City of Albuquerque

RE: REVISED CONCEPTUAL DRAINAGE PLAN FOR WYOMING COMMERCIAL
COMPLEX (E-19/D25C) REVISION DATE APRIL 2, 1990

WYOMING COMMERCIAL COMPLEX

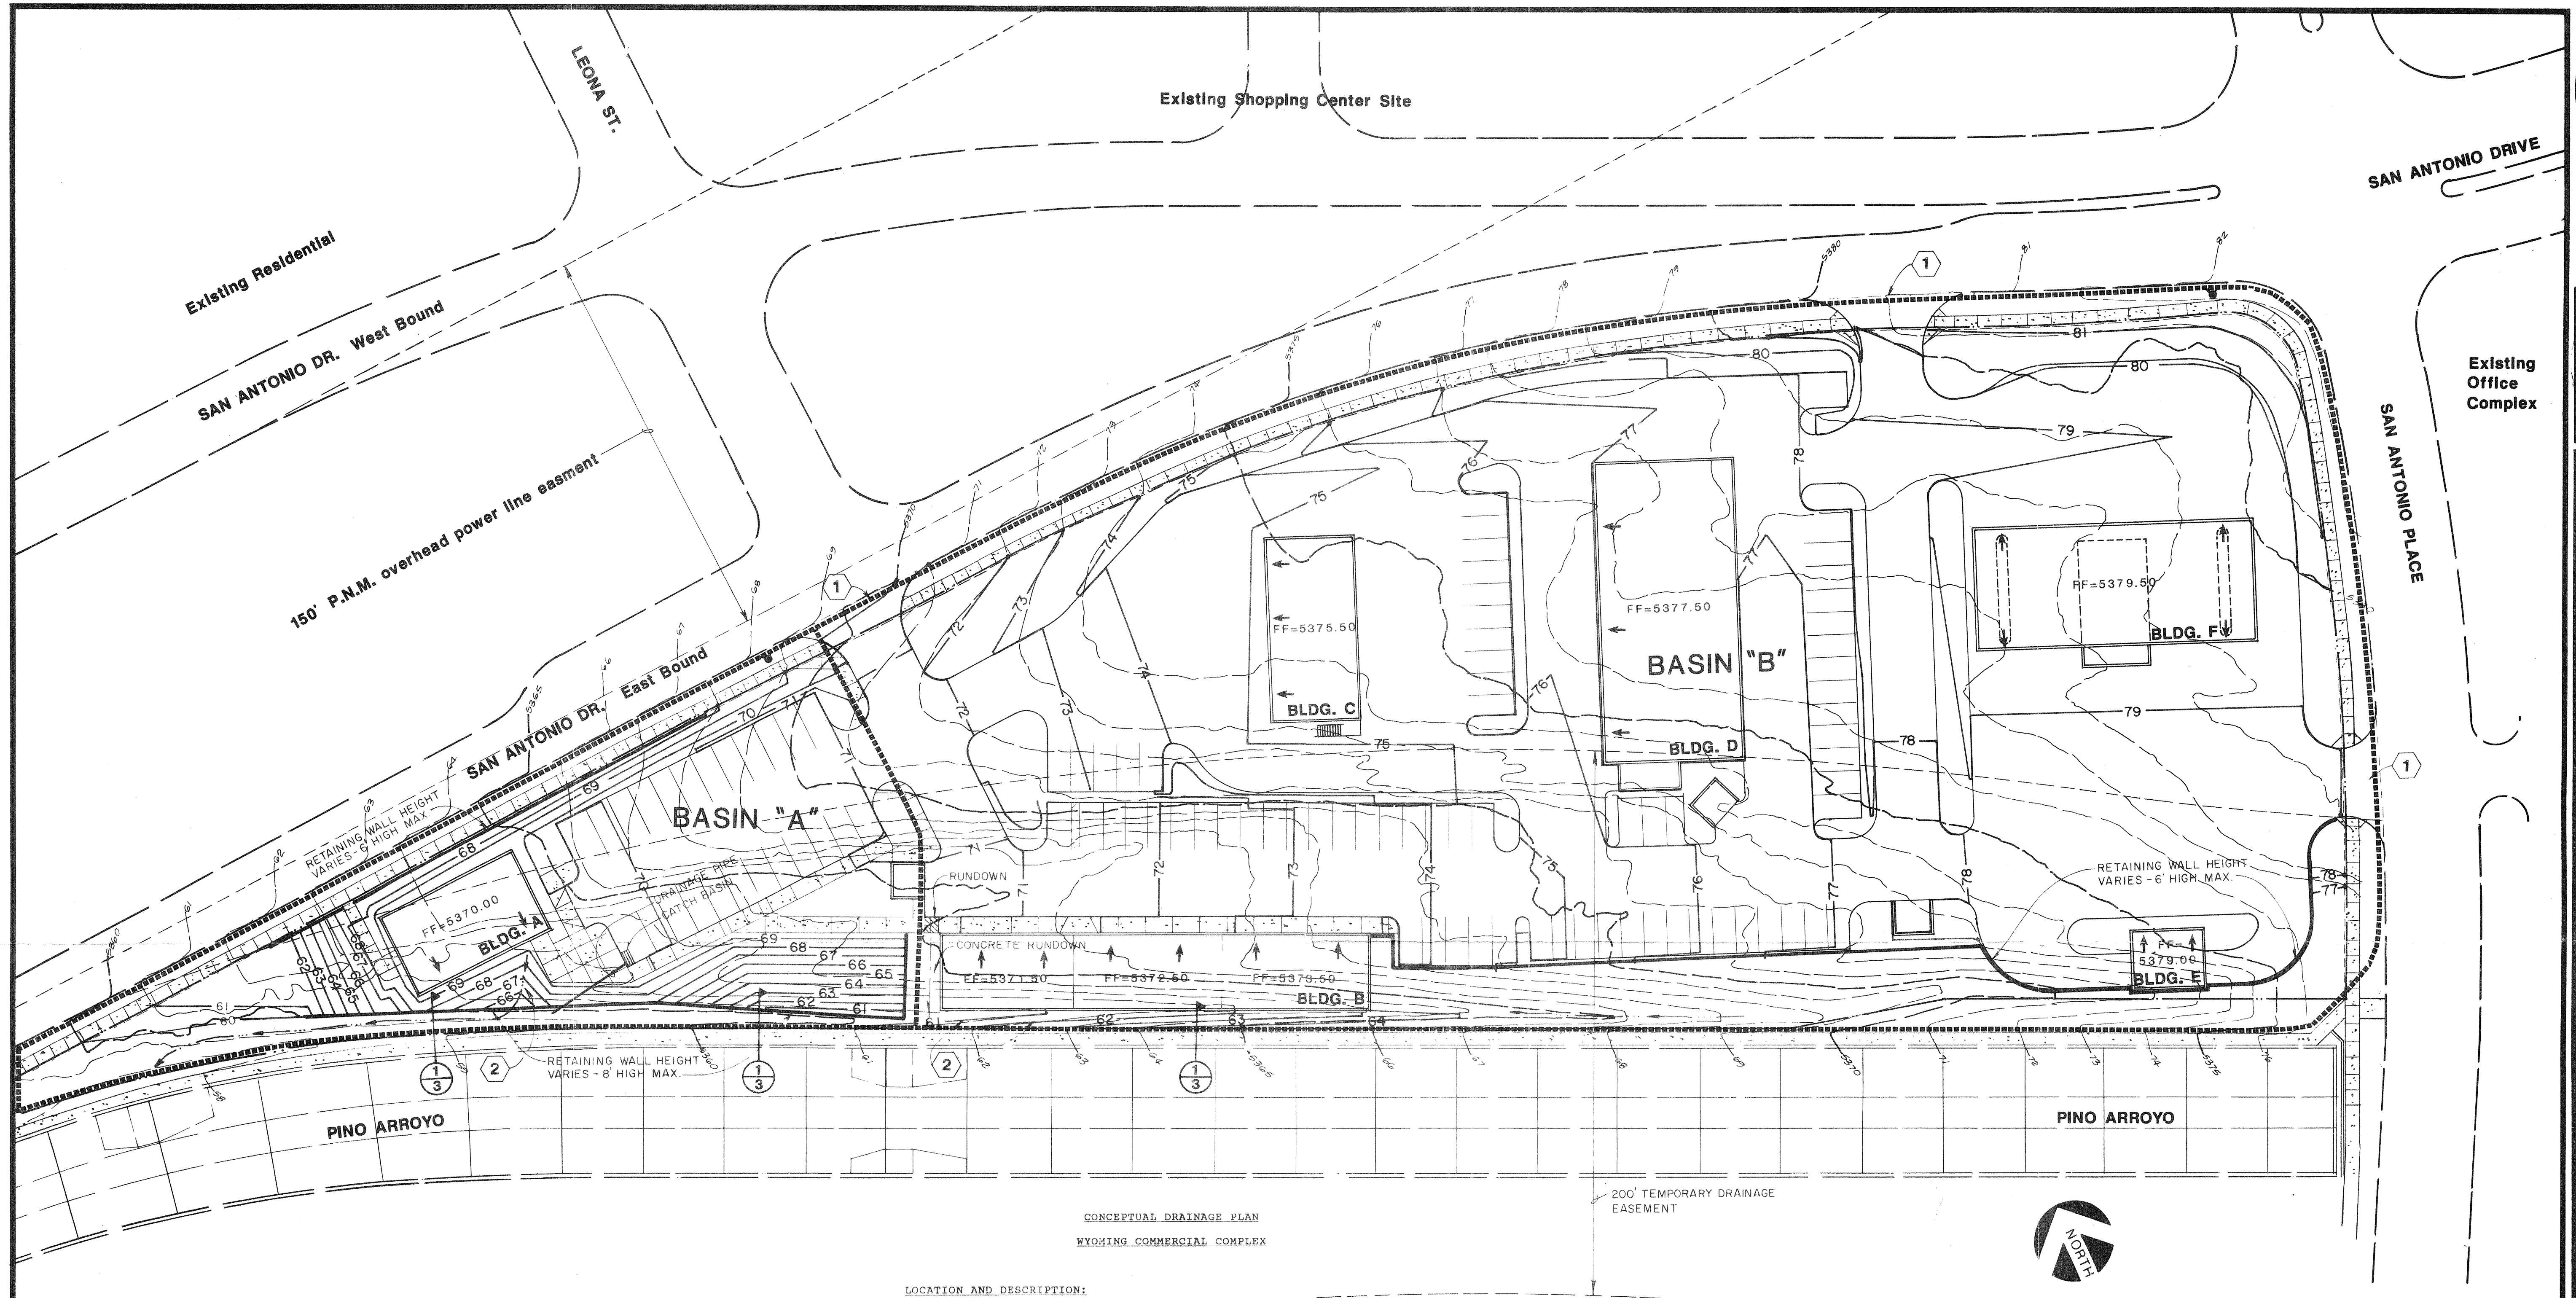
1. Based on the required configuration for capacity of the proposed rip-rap channel on the south side of the property, please provide a typical section with all the required dimensions. Also include the north right-of-way line on the plan drawing.
2. Please provide the hydraulics for the proposed rip-rap channel.
3. Please indicate the platted property lines on your resubmittal.
4. If phasing is going to be implemented, we will require a site specific plan for each site within each tract.
